Longs Ridge & Longs Creek

INFORMATION SHEET FOR
PRELIMINARY OVERALL AREA DEVELOPMENT PLAN
(P.O.A.D.P.)

RE: Long's Ridge and Long's Creek POADP
File #200.

Re: Long's Ridge and Long's Creek POADP
File # 85-18-63-88 (Revised November 27, 1985)

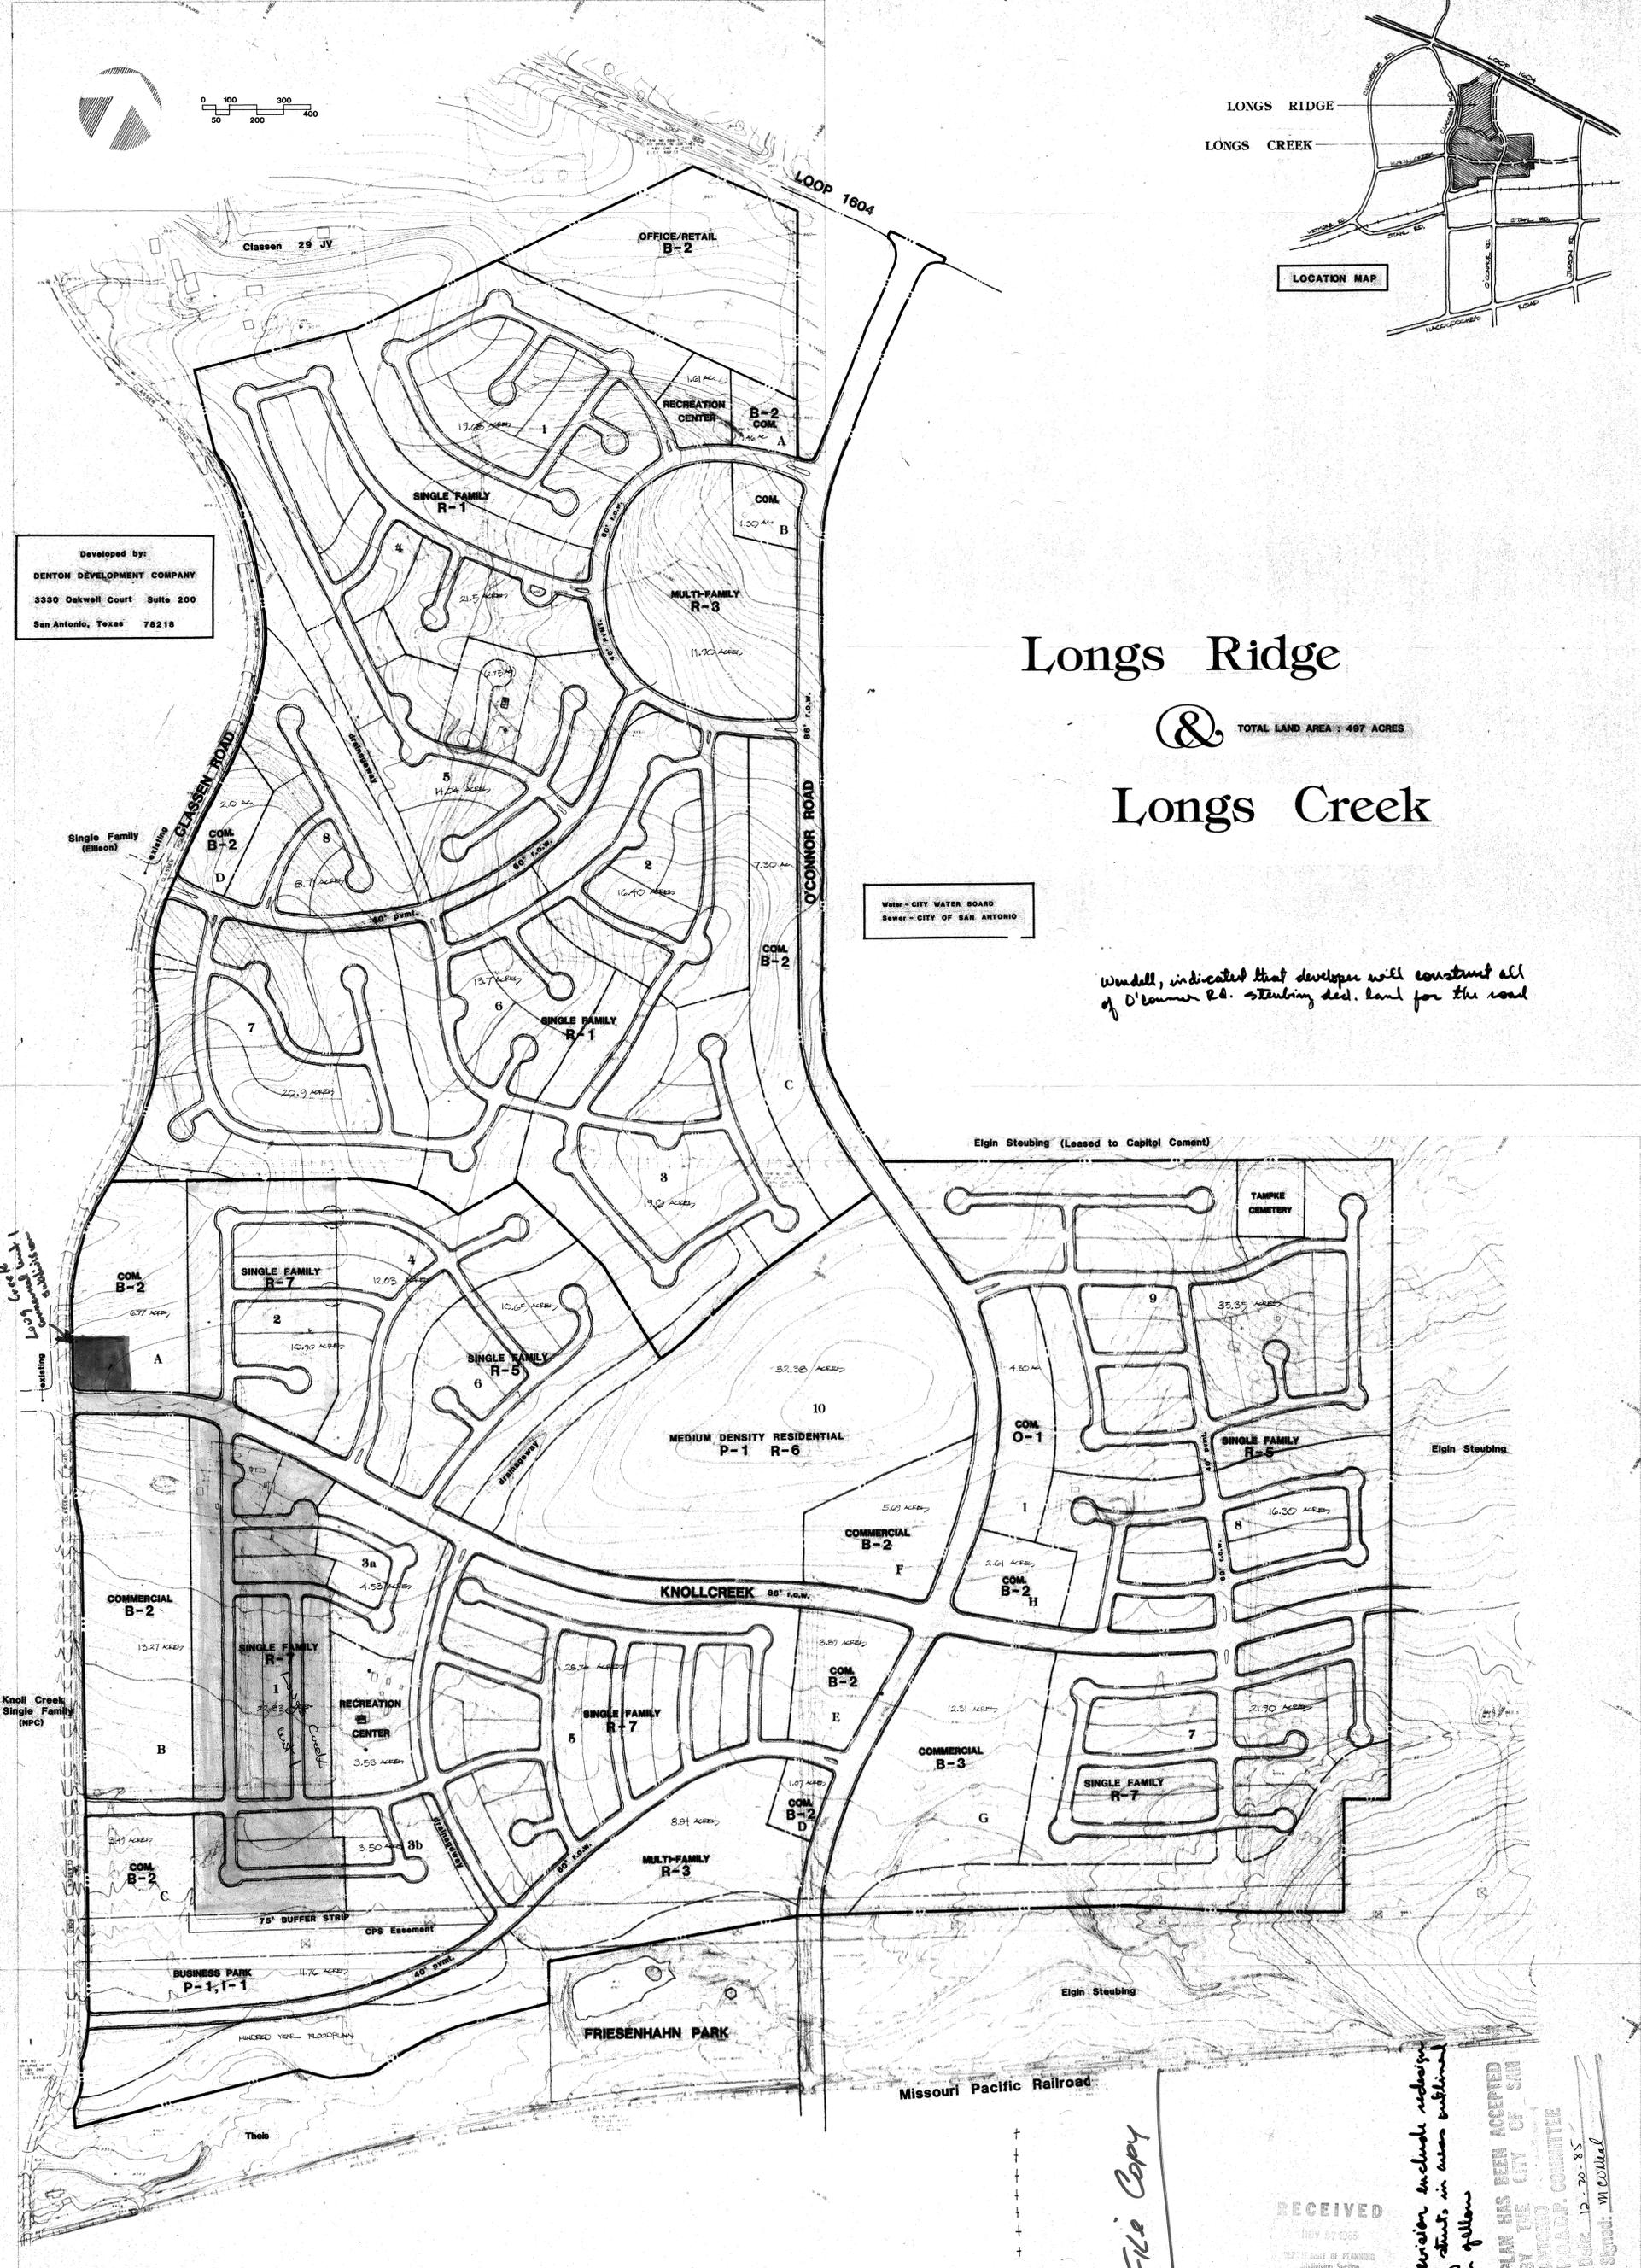
Wendell, indicated that developer will construct all of O'Connor Rd. - Steubing div. land for the road

The POADP Committee has reviewed and accepted the revised plan for Long's Ridge and Long's Creek. However, the Committee requests that you reconsider the alignment of the 60' street between Classen and O'Connor Roads as indicated on the attached plan. The Committee believes this street will and should function as a collector and that the revised alignment will create a potential safety hazard.
